BUFFALO RUN ACRES SUBDIVISION

CONSTRUCTION DOCUMENTS TAYLOR, WEBER COUNTY, UTAH

BUFFALO RUN ACRES SUBDIVISION
CONSTRUCTION DOCUMENTS

CE1-01

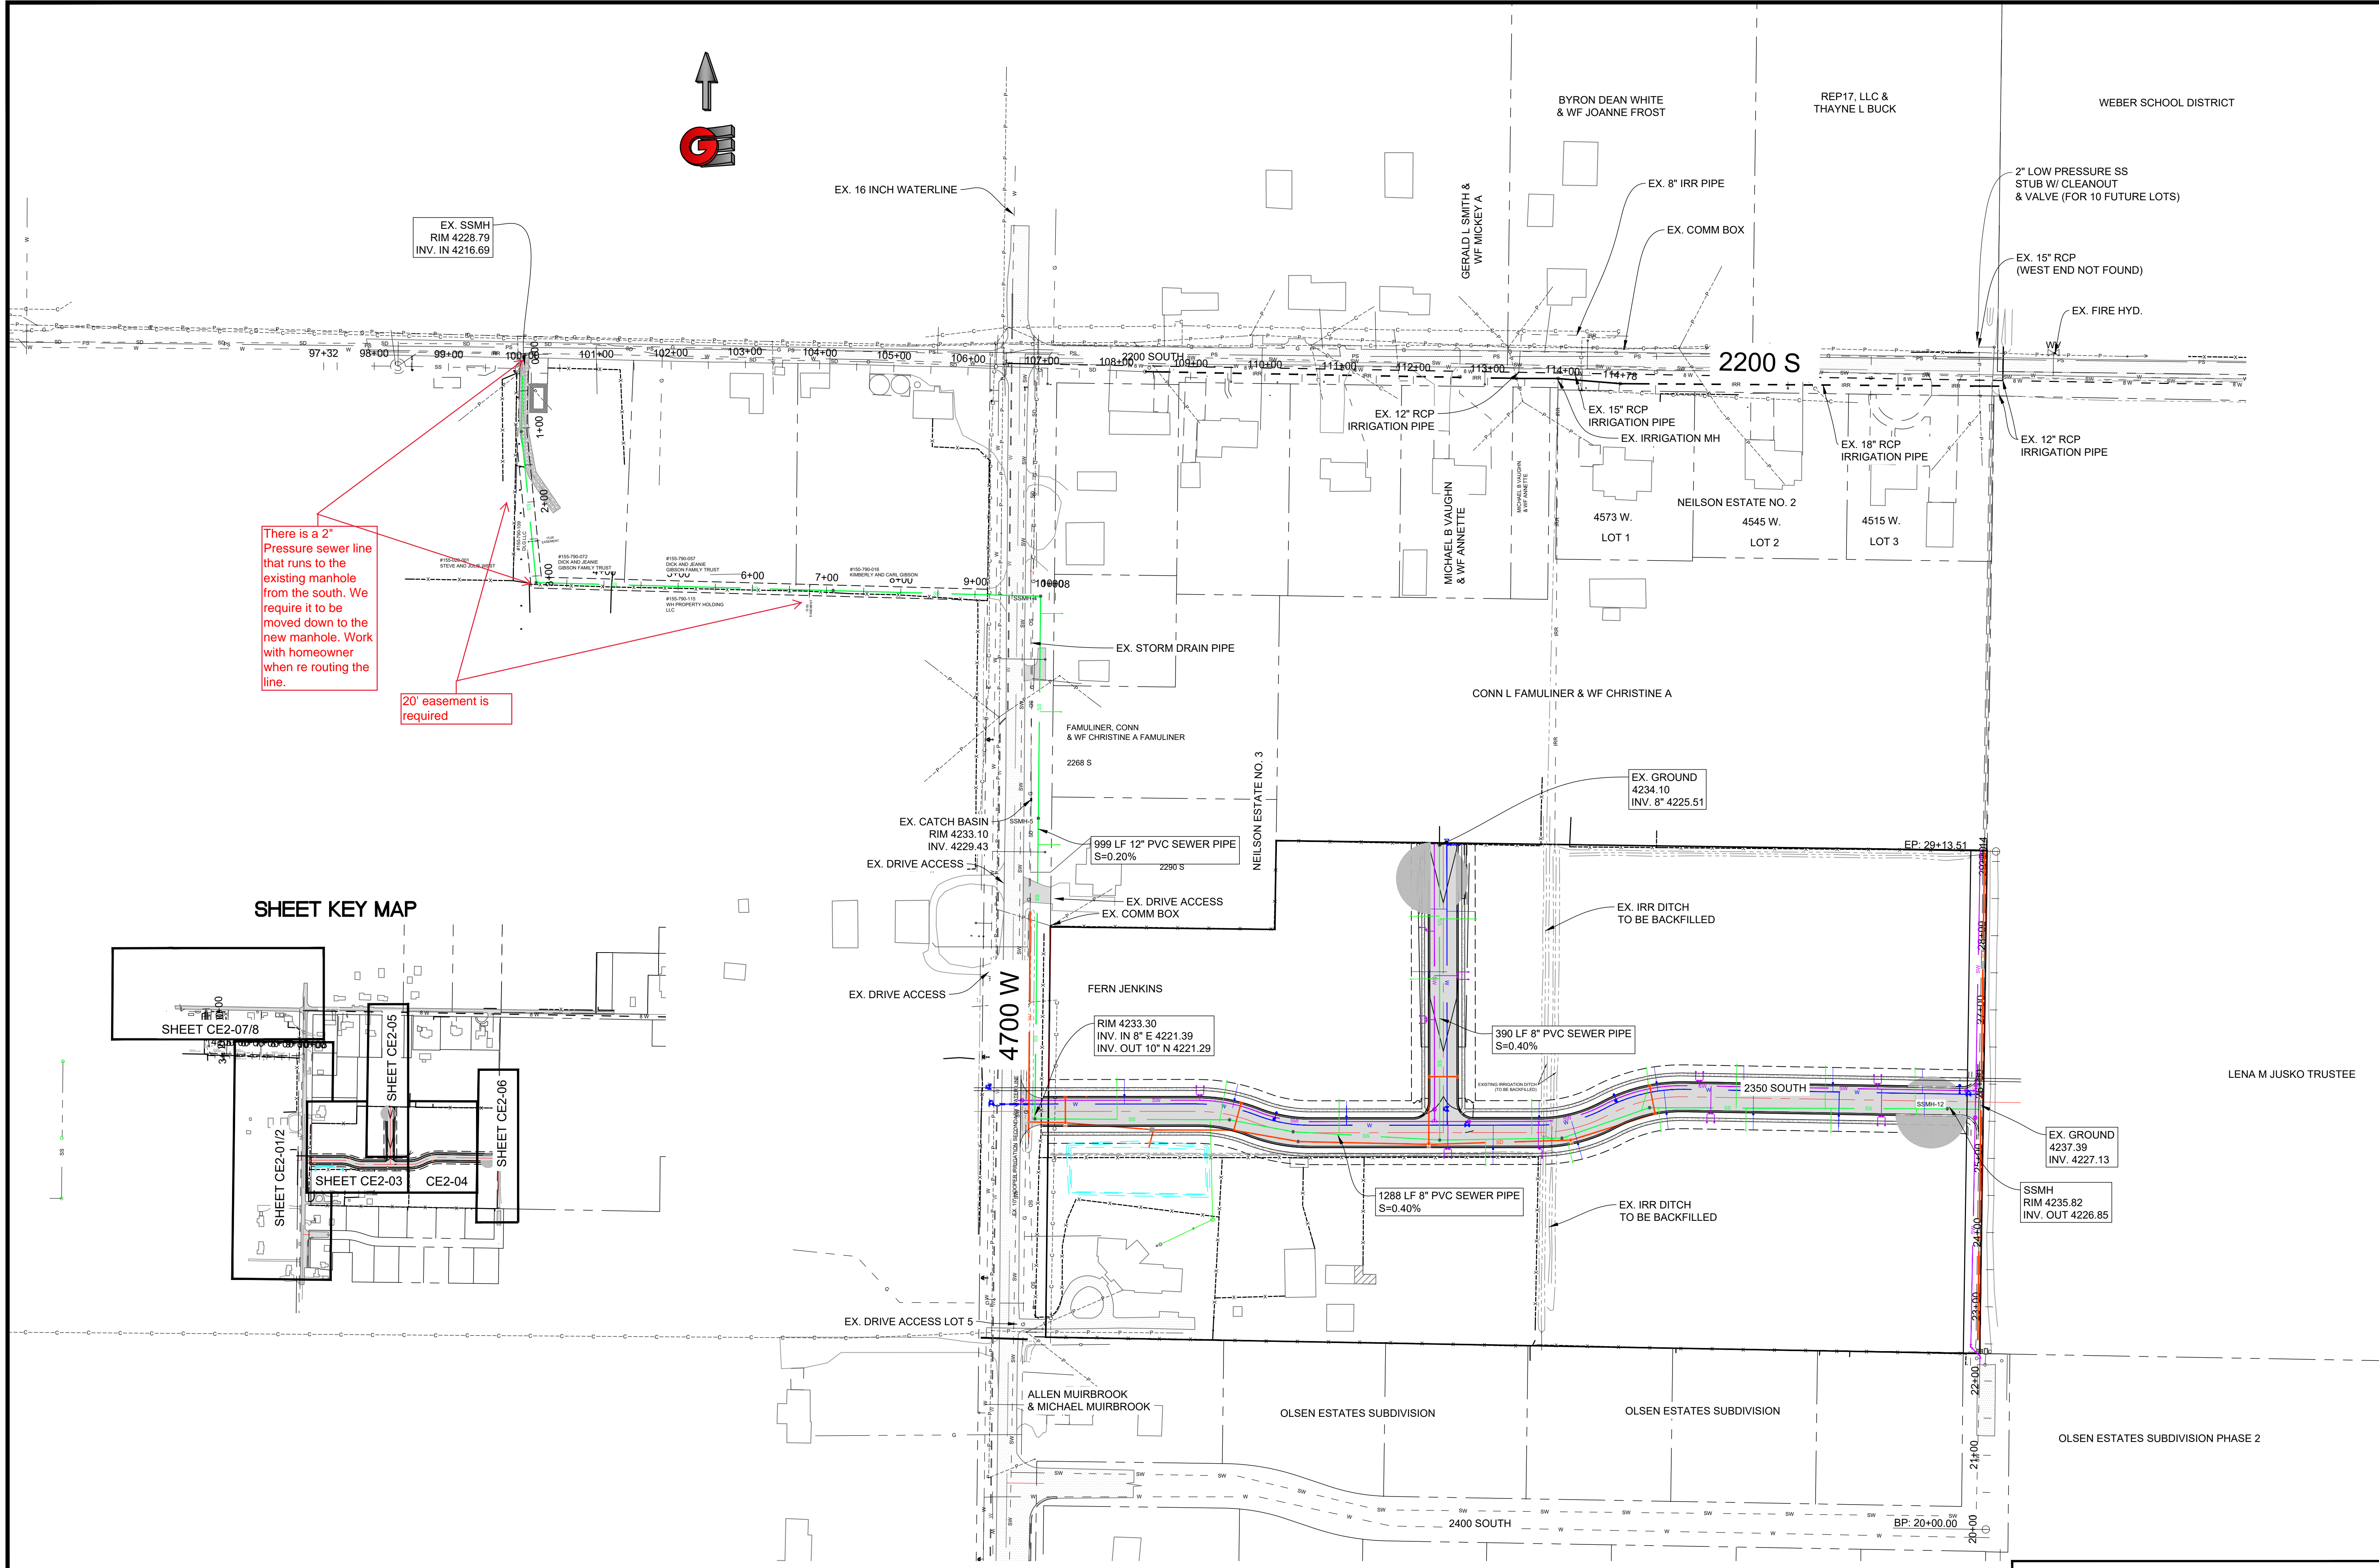
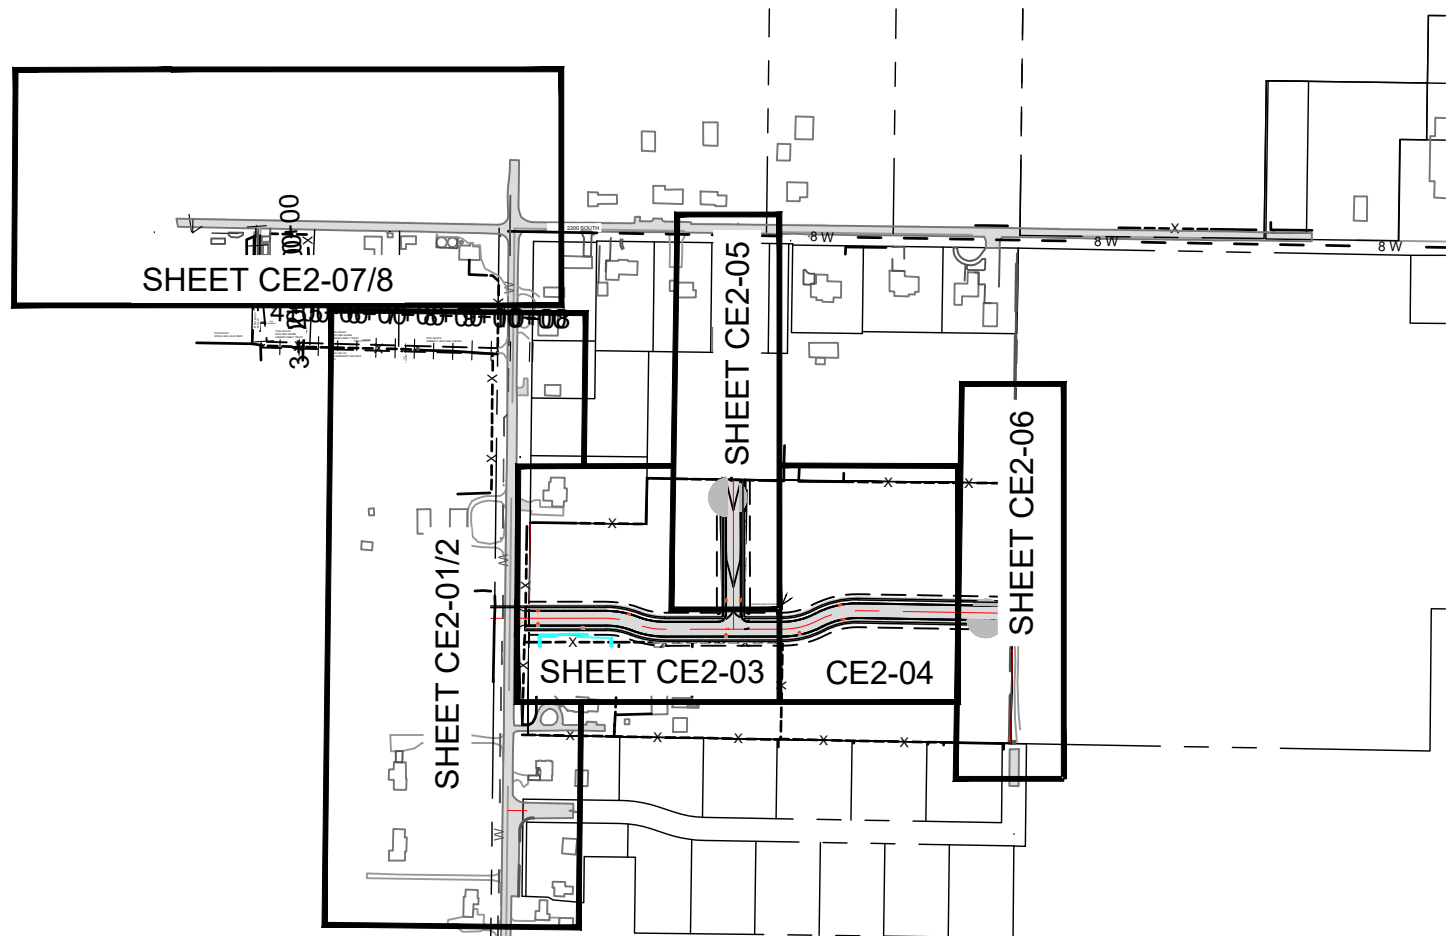
There is a 2" Pressure sewer line that runs to the existing manhole from the south. We require it to be moved down to the new manhole. Work with homeowner when re routing the line.

20' easement is required

CE2-02

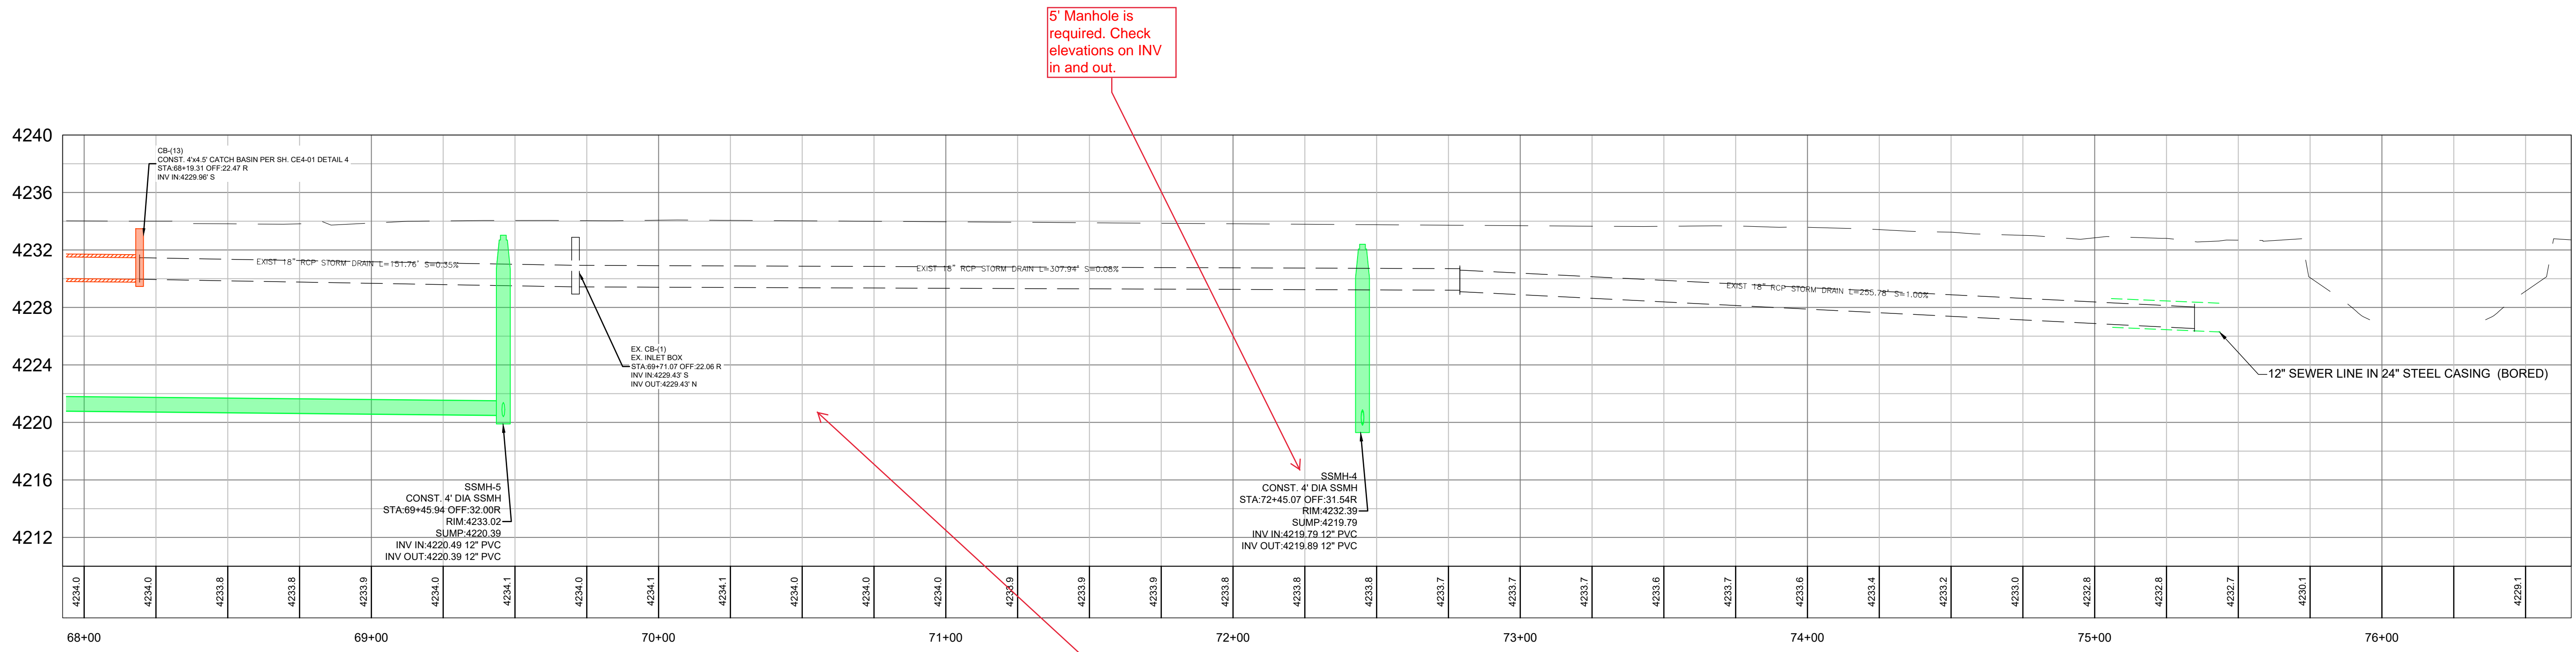
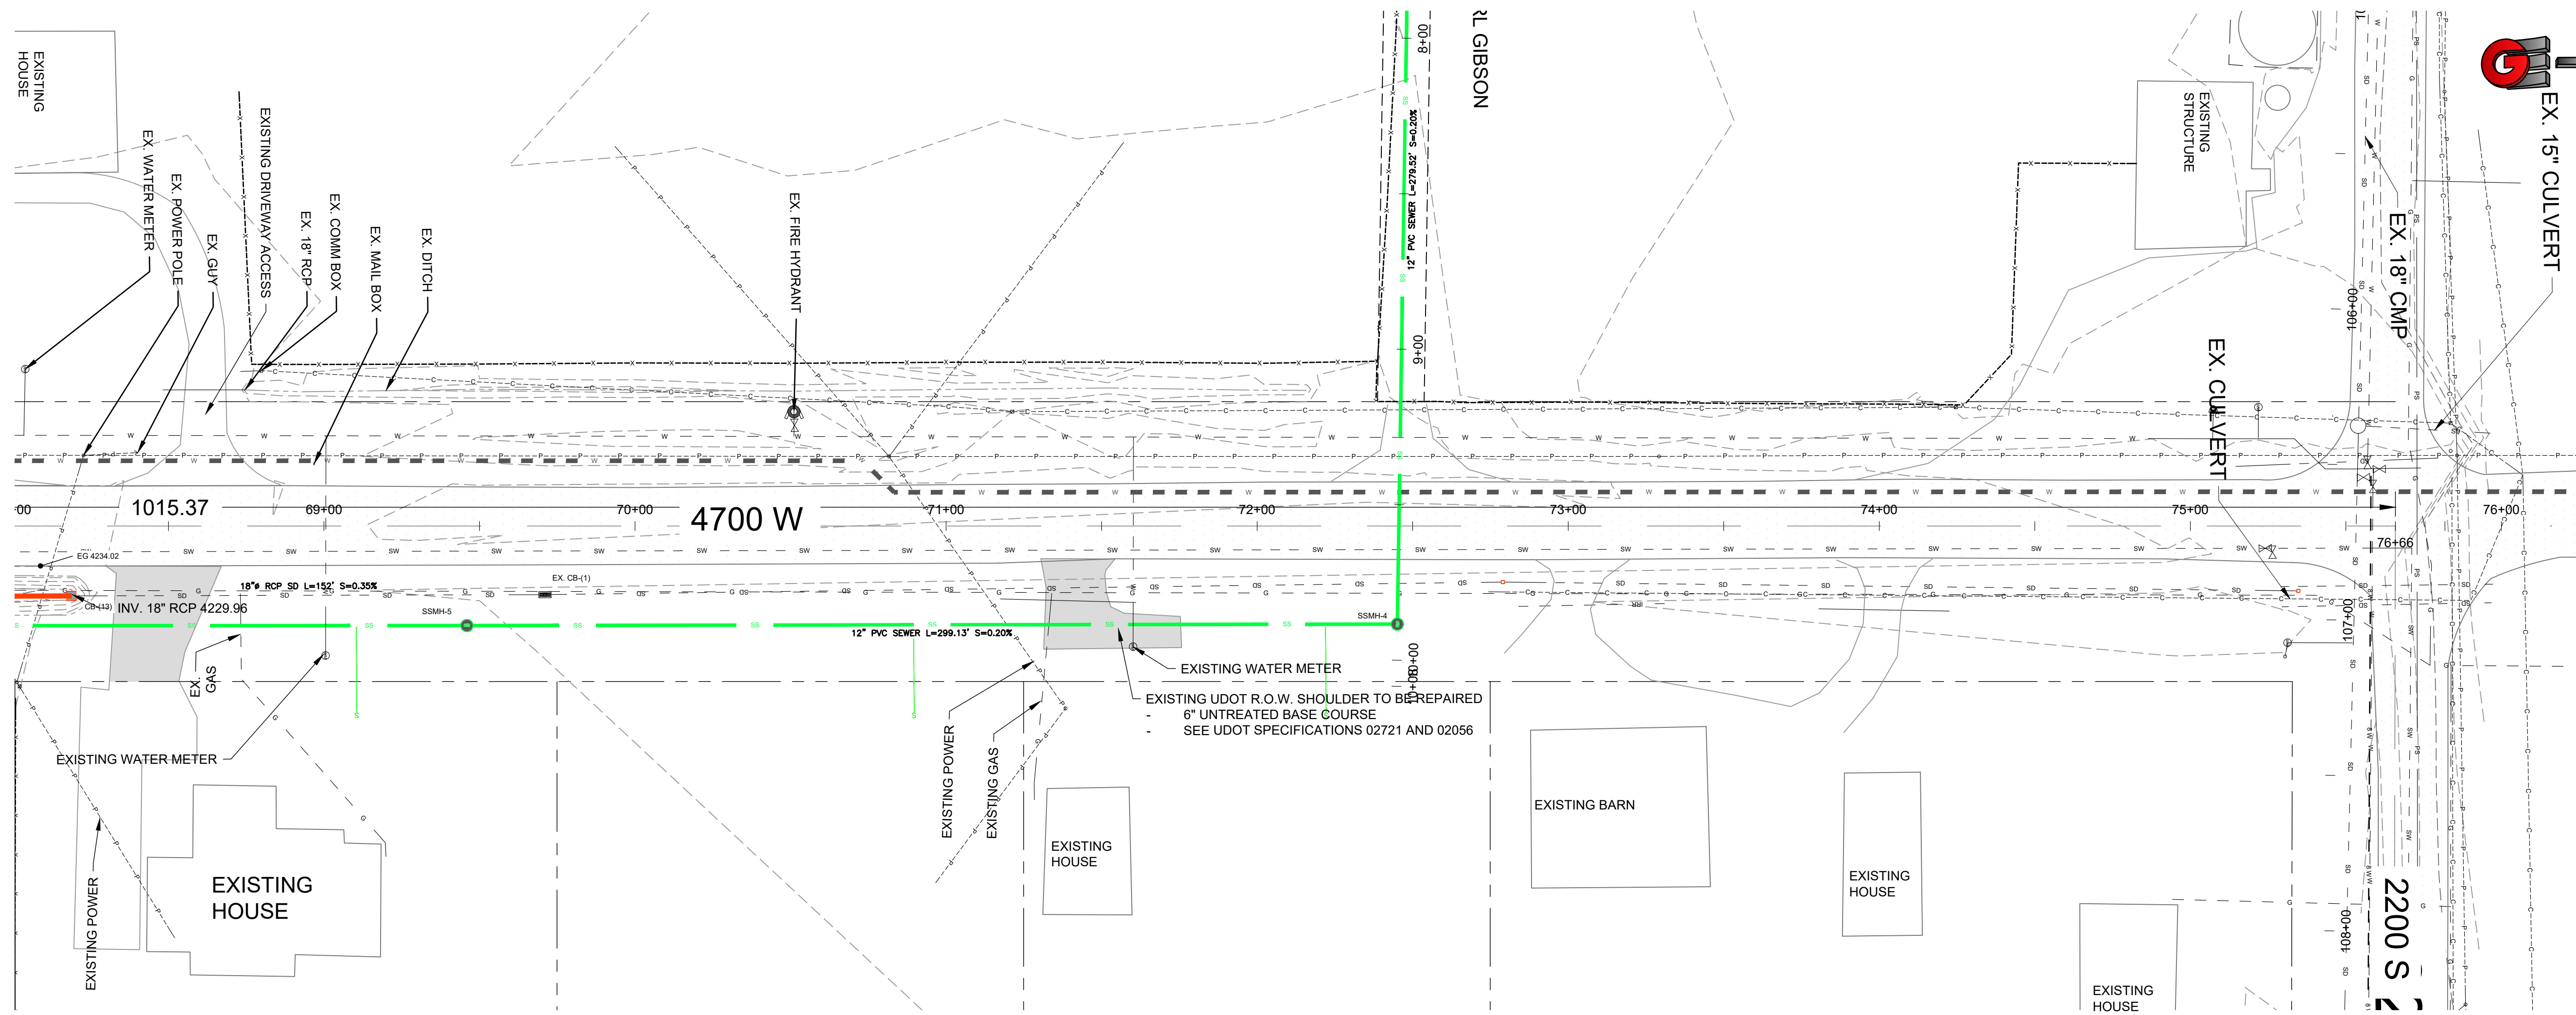
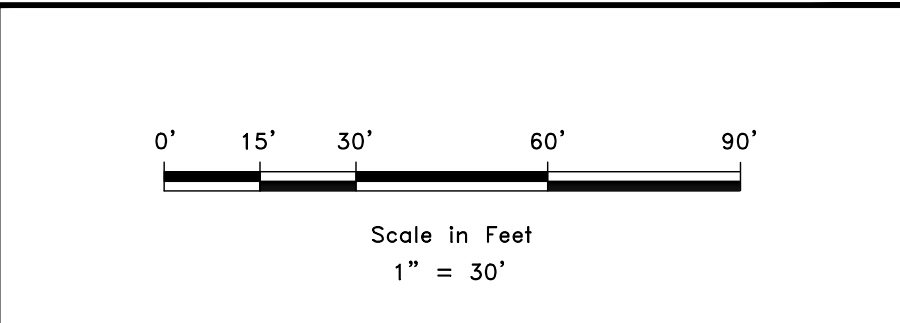
5' Manhole is required. Check elevations on INV in and out.

Show sewer line on profile
